Village of Mukwonago
Notice of Meeting and Agenda

PLAN COMMISSION MEETING
Tuesday, May 10, 2022

SITE PLAN AND ARCHITECTURAL REVIEW FOR HILL COURT PARTNERS RELOAD LLC

PLAN COMMISSION RESOLUTION APPROVING SITE PLAN AND ARCHITECTURAL REVIEW FOR A MULTI-TENANT BUILDING LOCATED AT 115 HILL COURT (PARCEL NUMBER A493600002)

C5.0
SHEET 5 OF 5

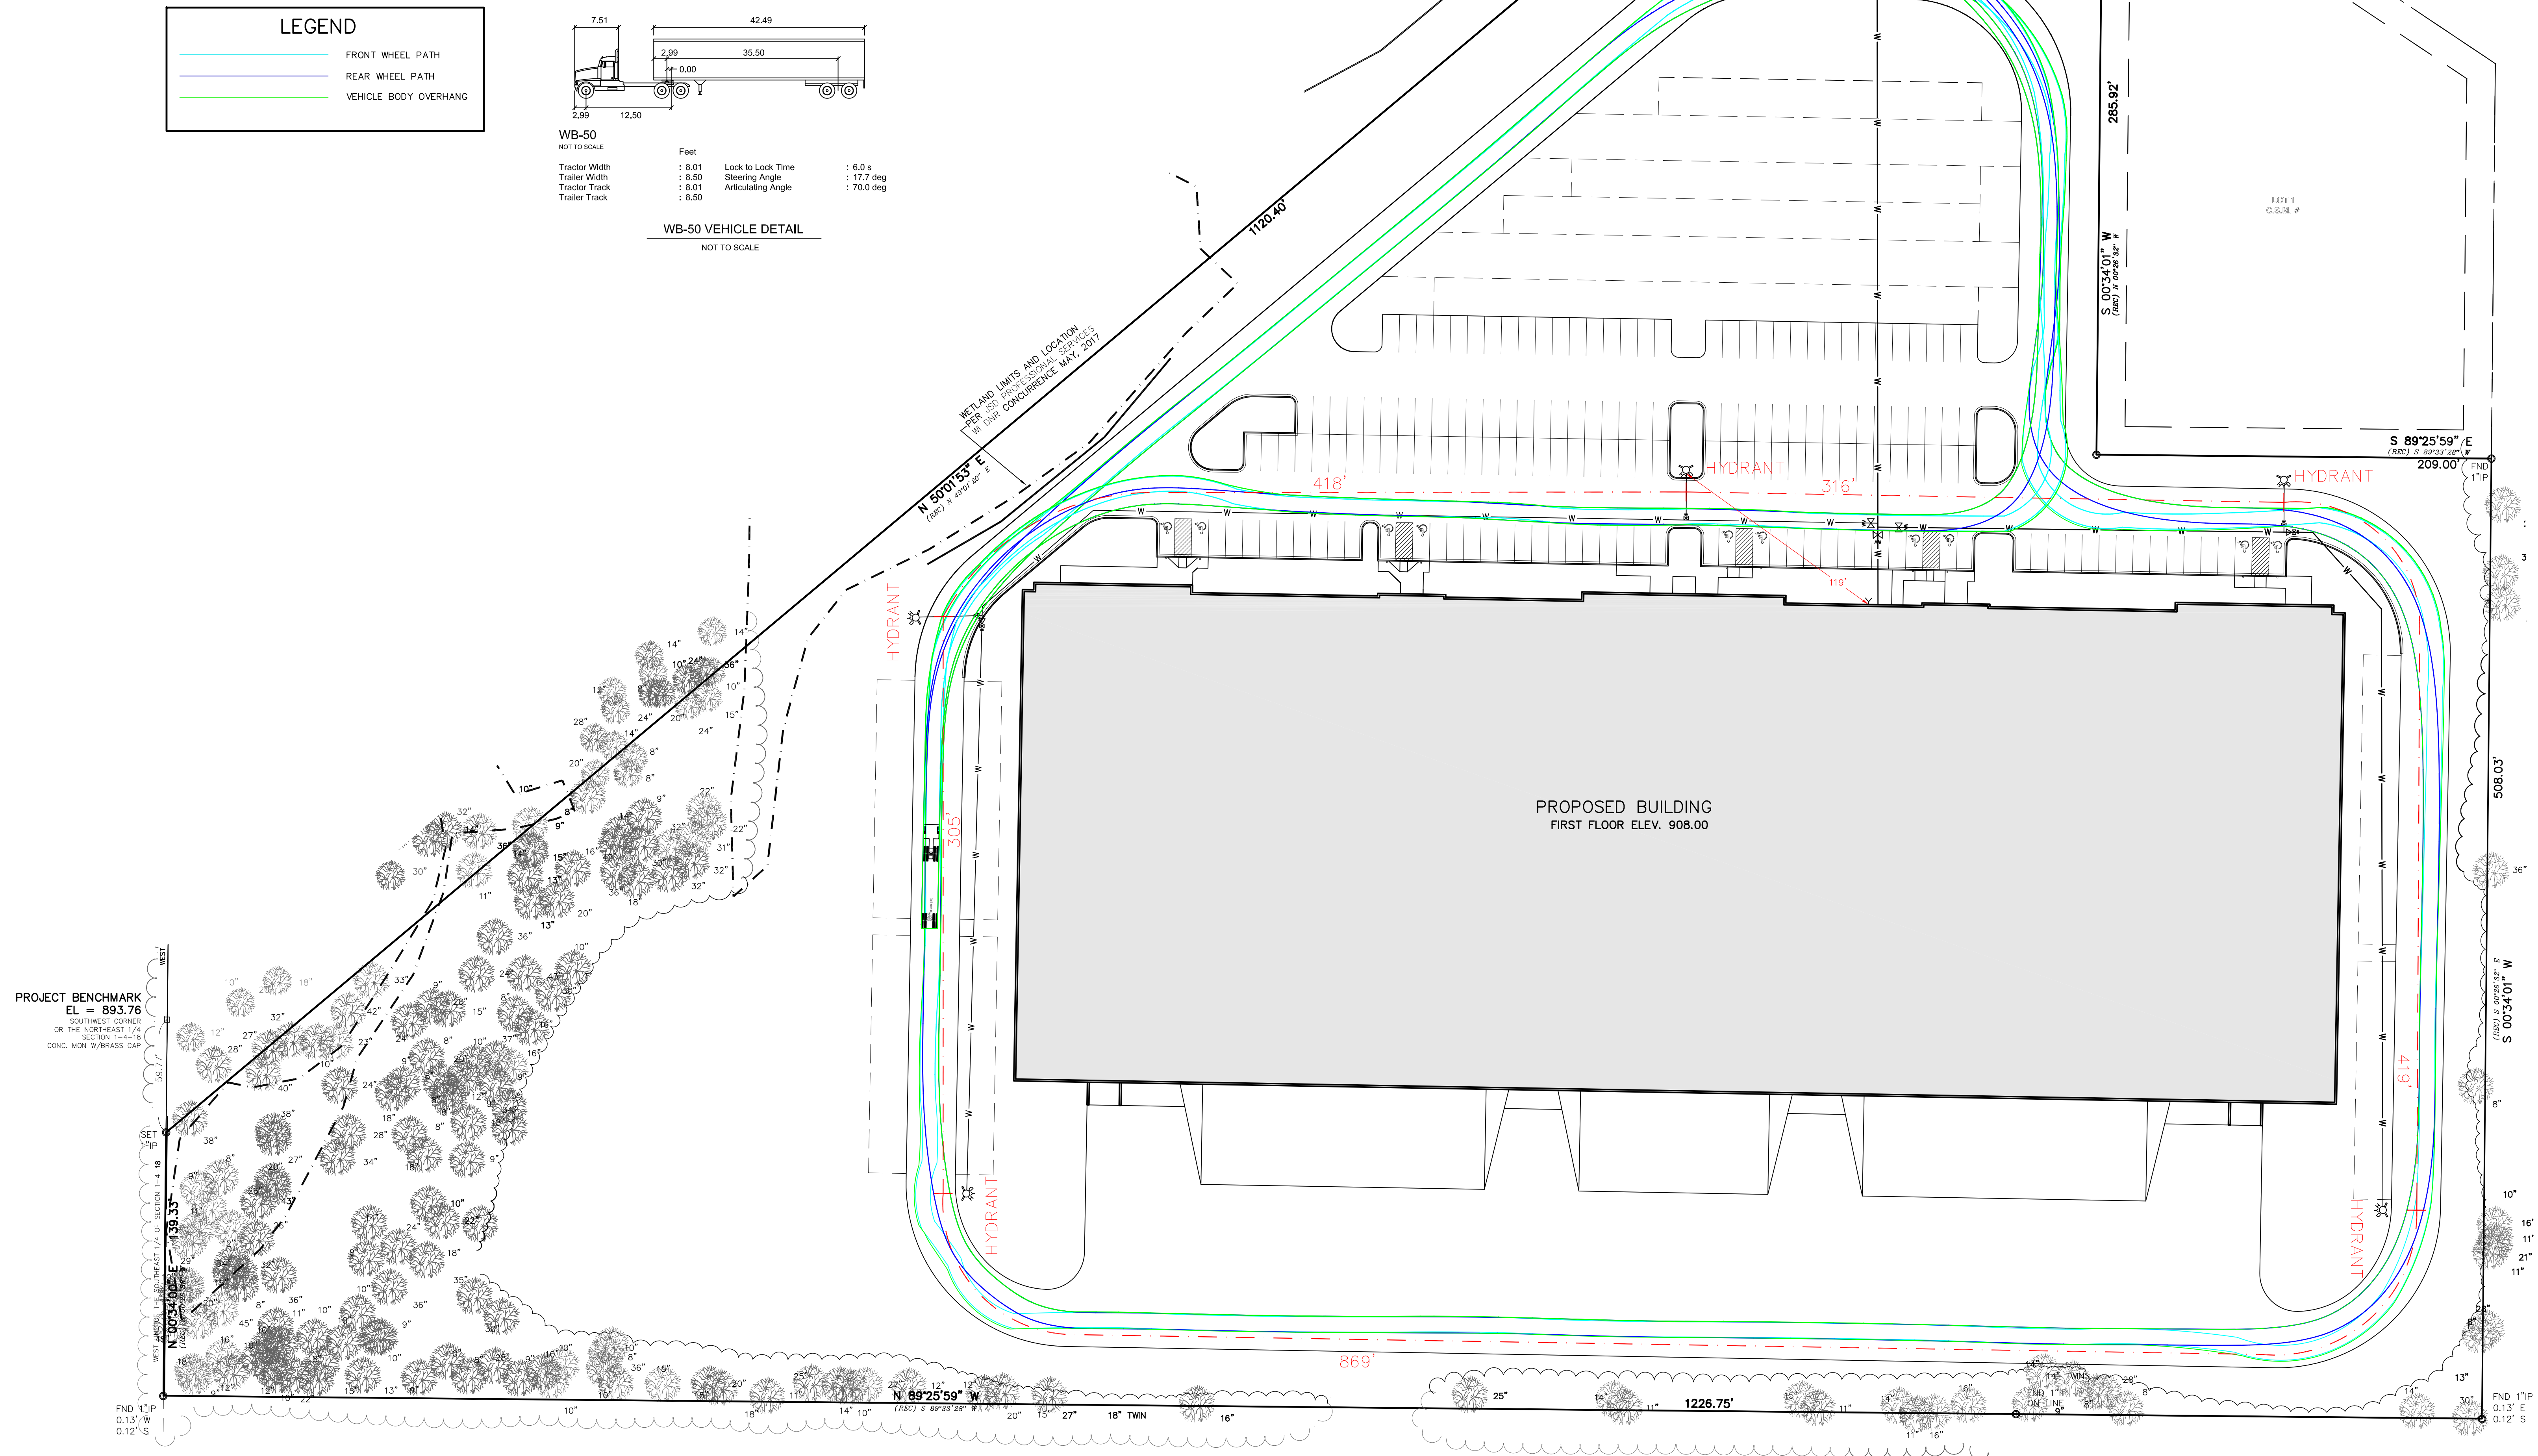
Fire protection The site has been designed to accommodate fire protection vehicles (WB-50 vehicle). (See Sheet C5.0)

1 ARCHITECTURAL SITE PLAN
1" = 40'-0"

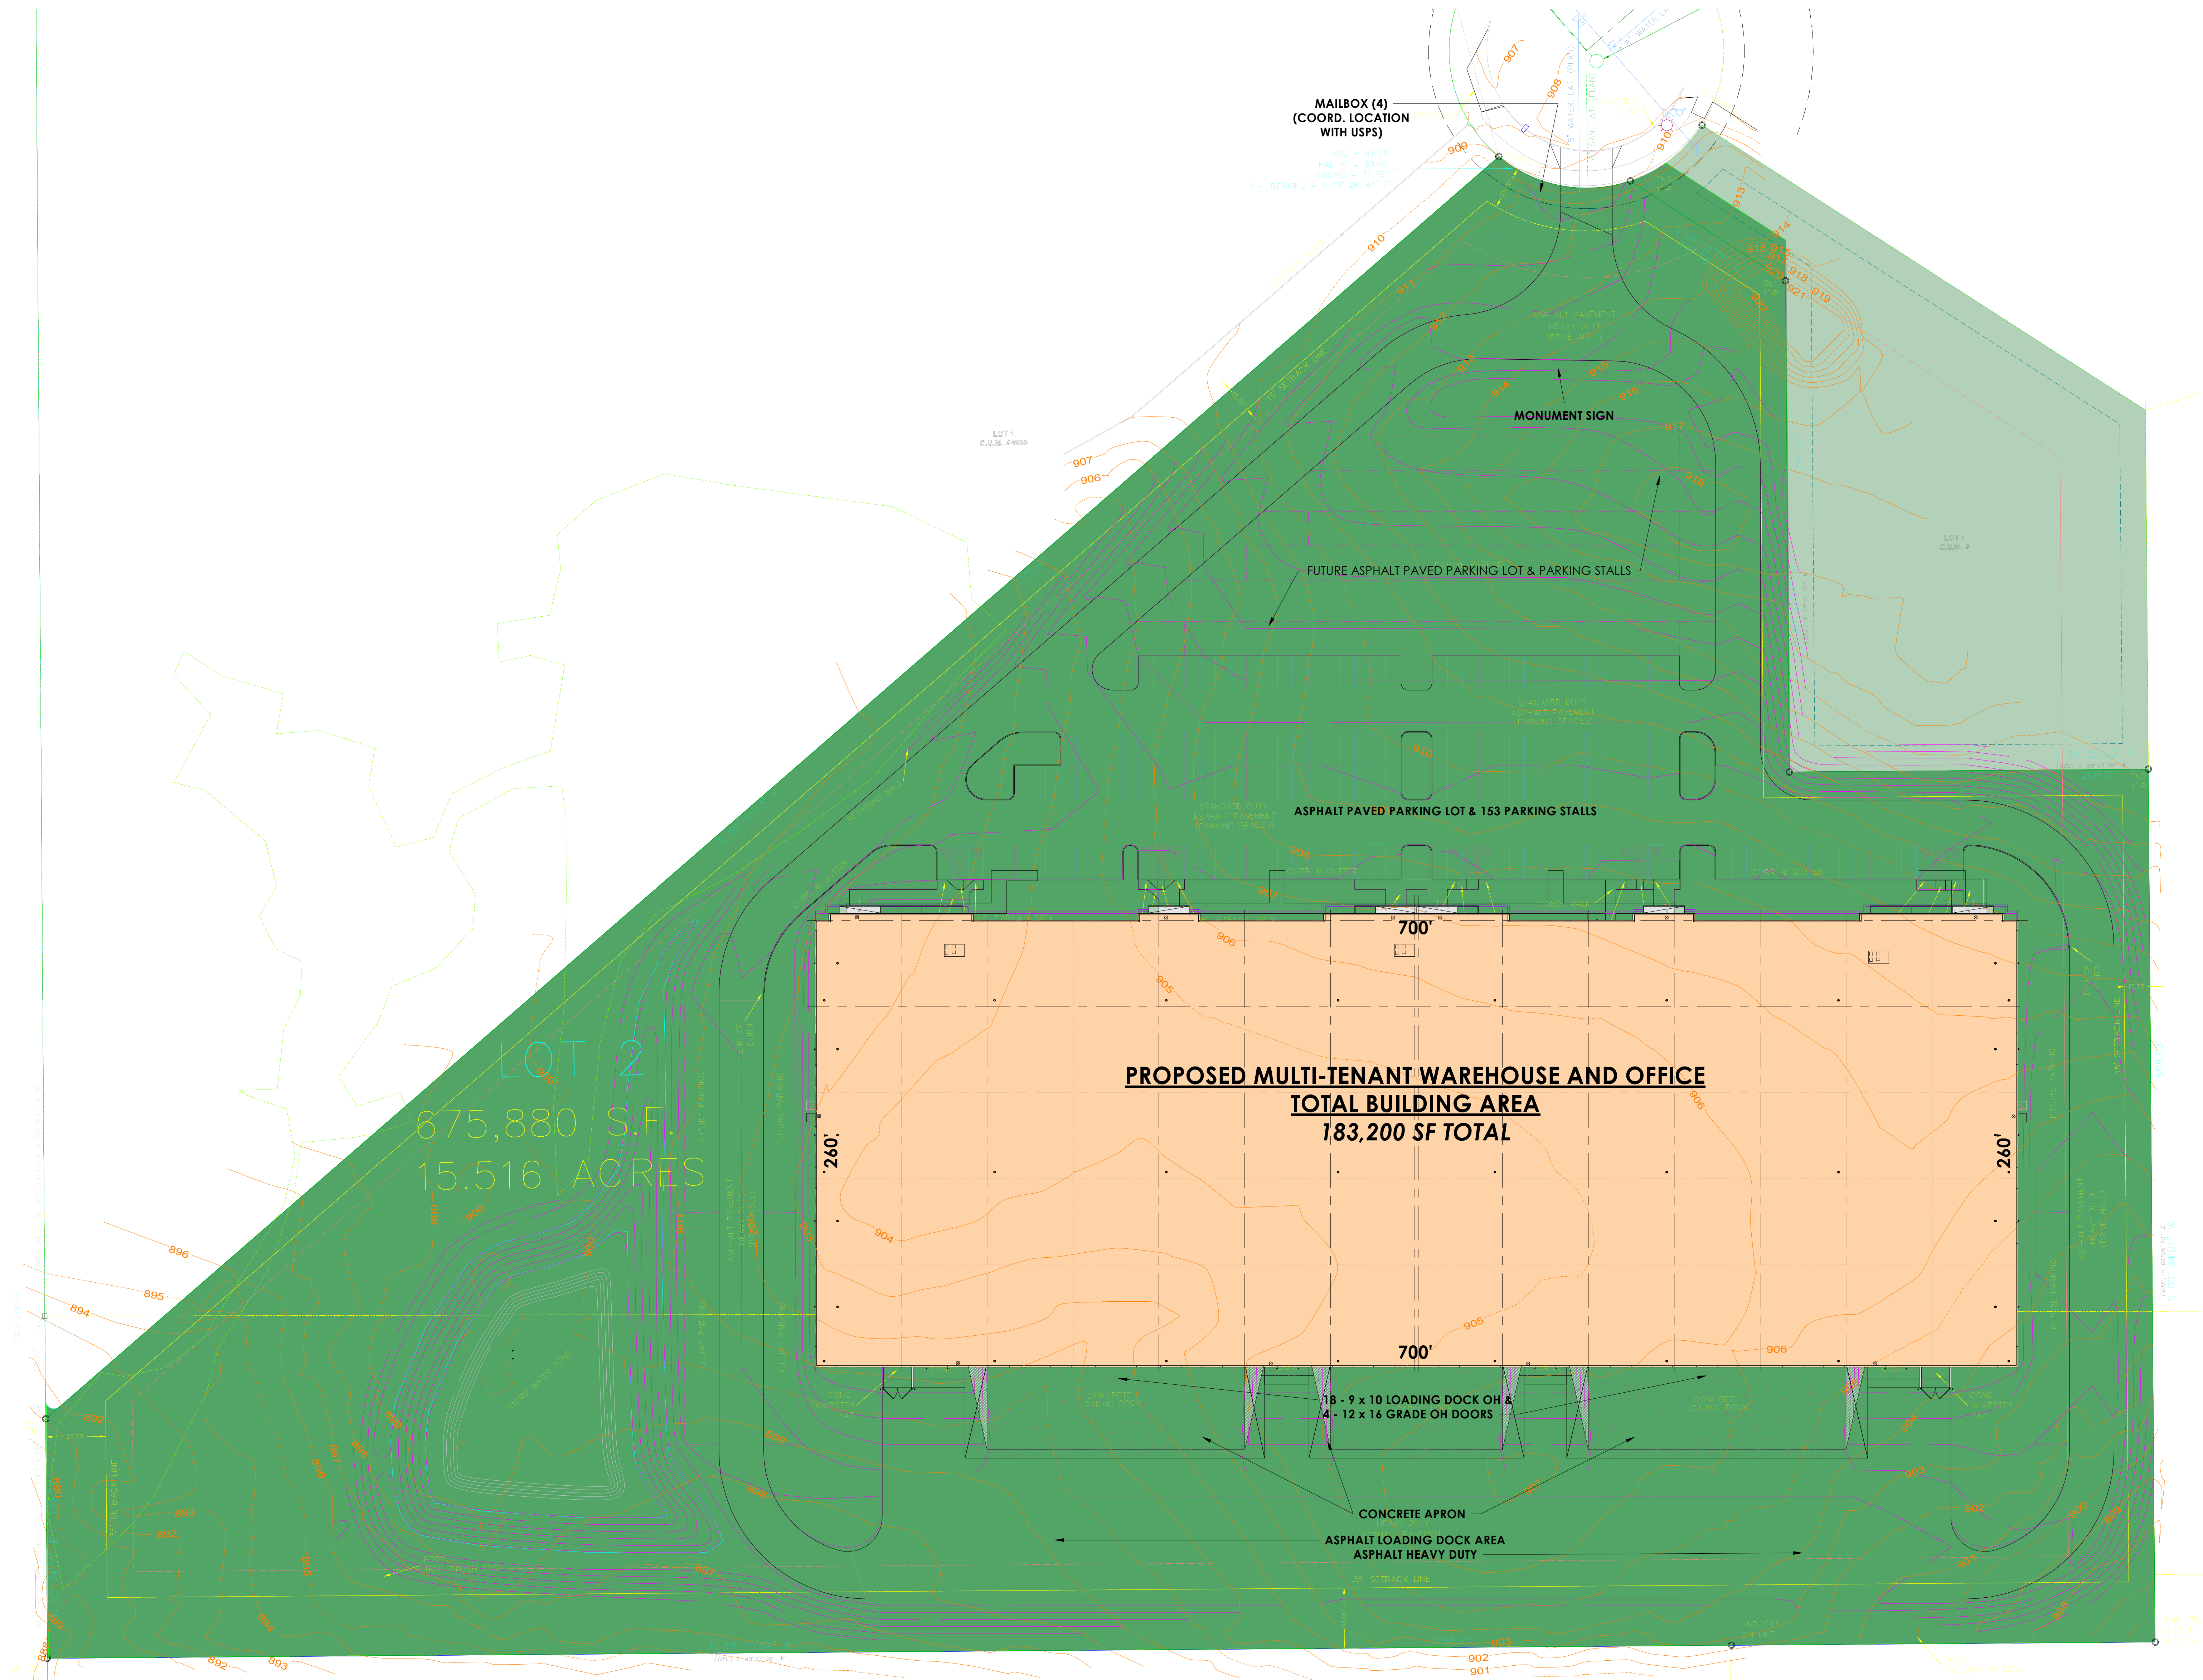
Parking The site plan shows 168 parking spaces with the potential of another 190 spaces that could be developed in the future if the occupancy required such parking. Ultimately, the property owner will need to manage what tenants occupy the various spaces so that collectively there is enough parking for all tenants. A sidewalk should be added in front of the parking spaces along the front of the building.

Trash enclosure As set forth in Section 100-206(g) of the zoning code, trash dumpsters must be enclosed within a 6-foot high wall/fence. The site plan should be revised accordingly and submitted for review.

1. The site plan should be revised to show a sidewalk along the parking lot in front of the building.
2. Plans for the dumpster enclosures must be submitted to the Village Planner and obtain approval of the same.

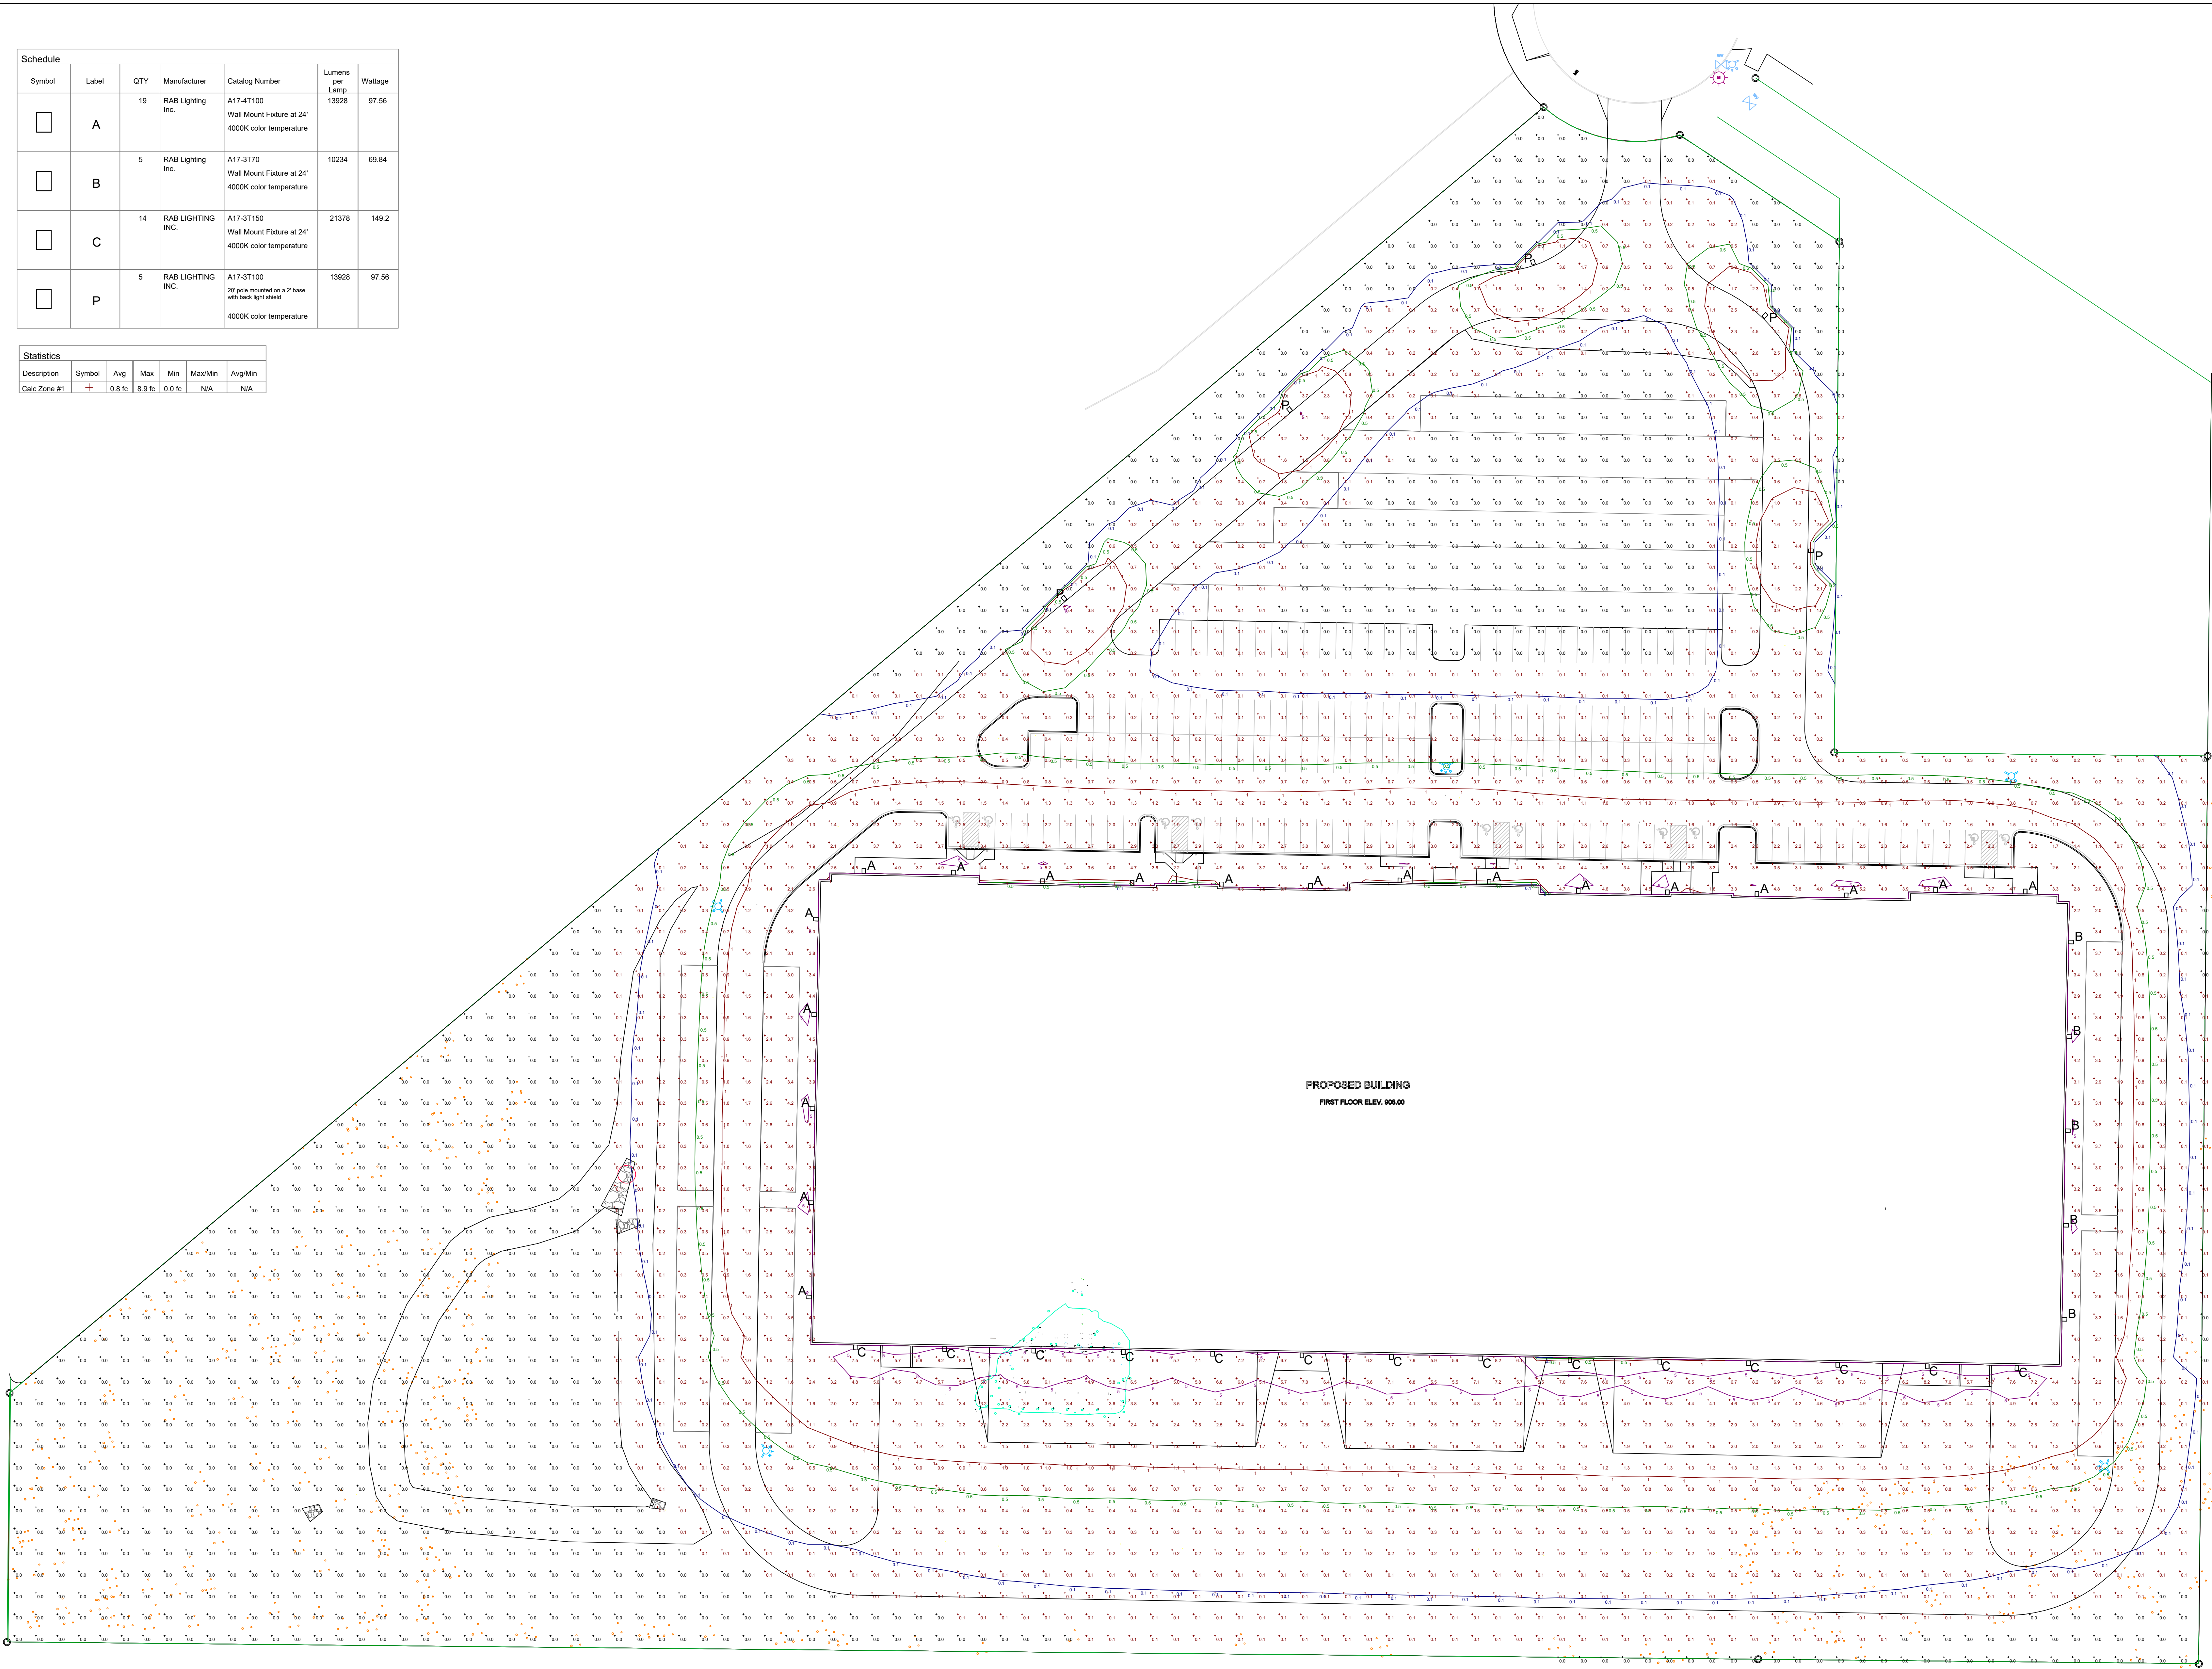
Outdoor lighting Outdoor lighting consists of wall packs and parking lot lights. Light poles comply with the maximum height of 25 feet. All fixtures are full cutoff. Lighting levels at the lot lines is zero footcandles as required (Sheet E-1).
